From: Green, Sandra [REDACTED]
Sent: 04 July 2023 11:17
To: Section 62A Applications <section62a@planninginspectorate.gov.uk>
Subject: S62A/2023/0017 Land at Tilekiln Green - National Trust Supplementary Reps - Low Bridge Signage

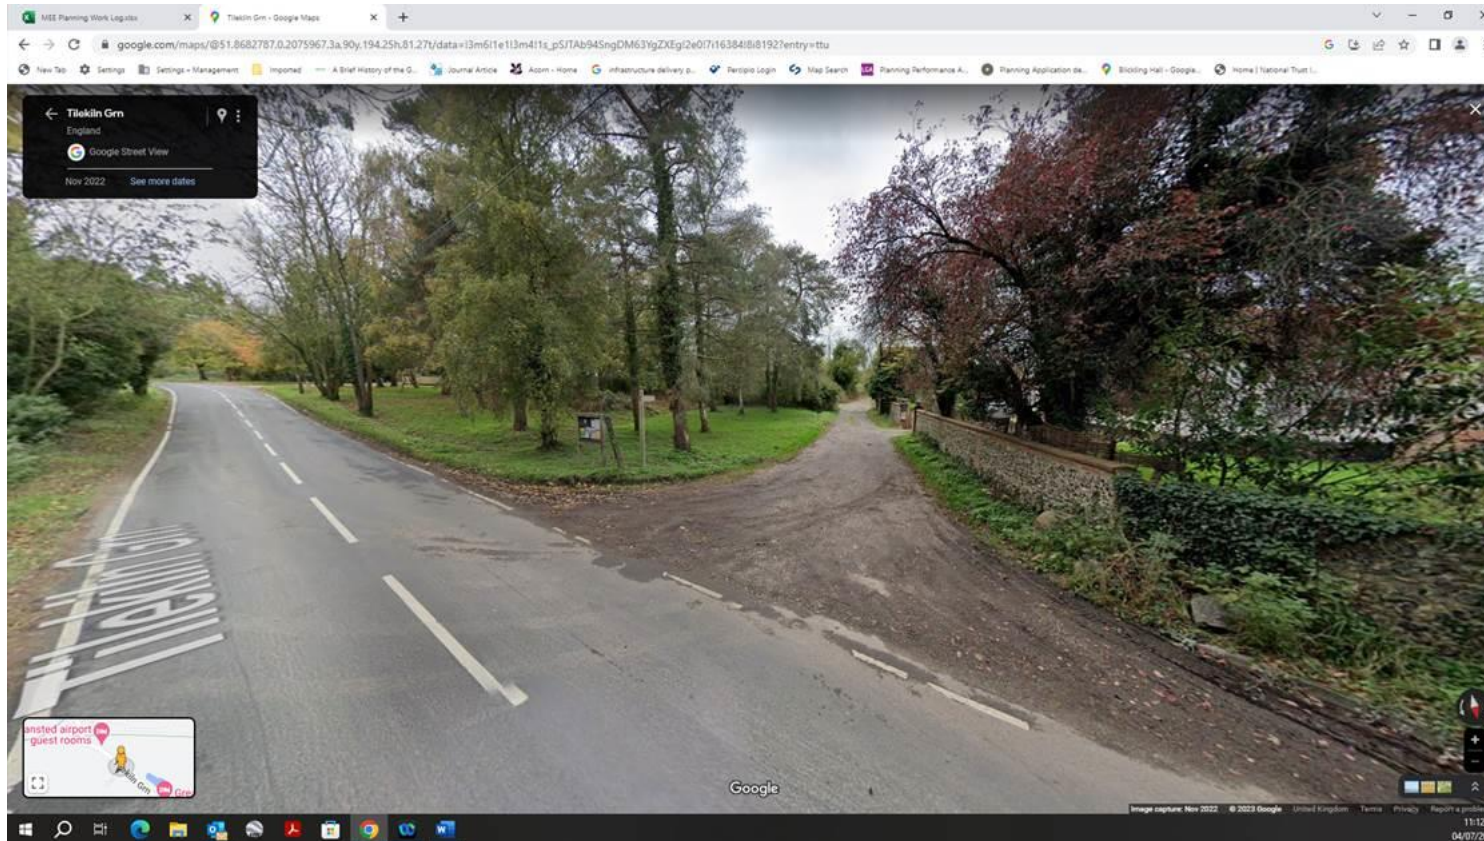
Further to my representations of 16/5/23 setting out the need for improved signage to the south of the low bridge.

- Traffic Signs Manual Chapter 4 Warning Signs 2018, Section 7 advises signage should be placed where the driver can see it in good time to make the necessary manoeuvre.
- The current height warning sign to the south of the bridge is located opposite Hill View, approximately 85m from the bridge and 1.25km from the Church Road/Tilekiln Green junction.
- When HGVs reach this point there is no room to turn around, necessitating HGVs to reverse back along the highway around the bend until they find space to turn, which has led to damage to the historic green.

Figure 7-13 Signs on approach to a non-arch bridge with a diversionary route

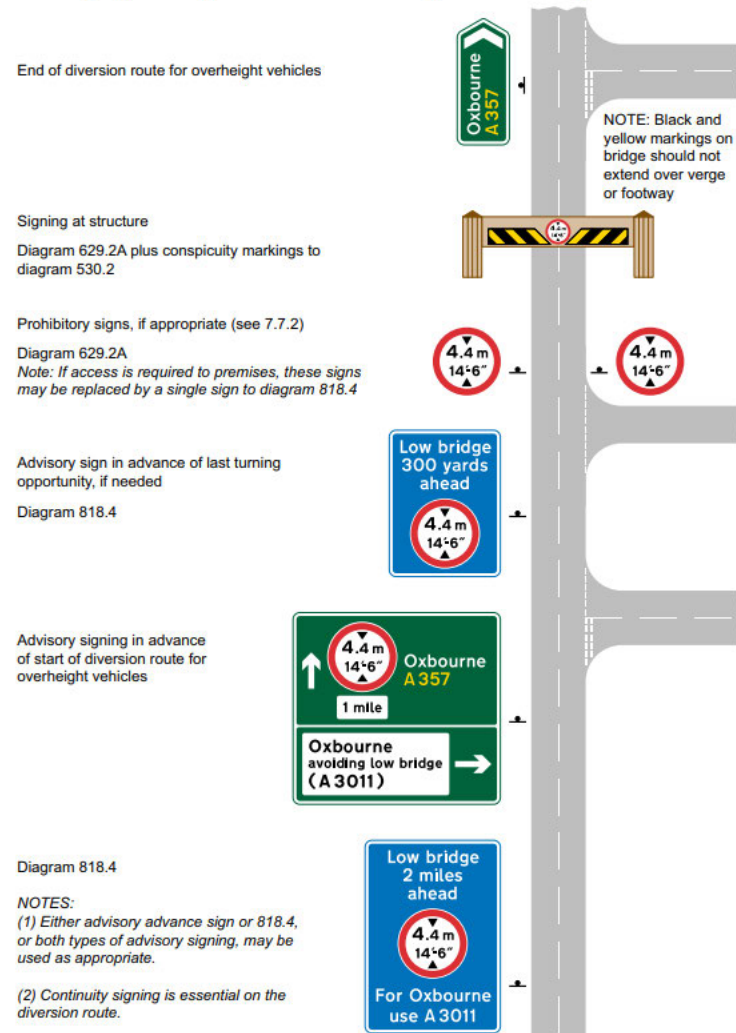
- Appropriate advisory signage is needed therefore in advance of the last turning opportunity akin to that shown in Figure 7-13 of the manual.

7.7.5. The signing on the approach to a non-arch bridge is shown in **Figure 7-13** below.
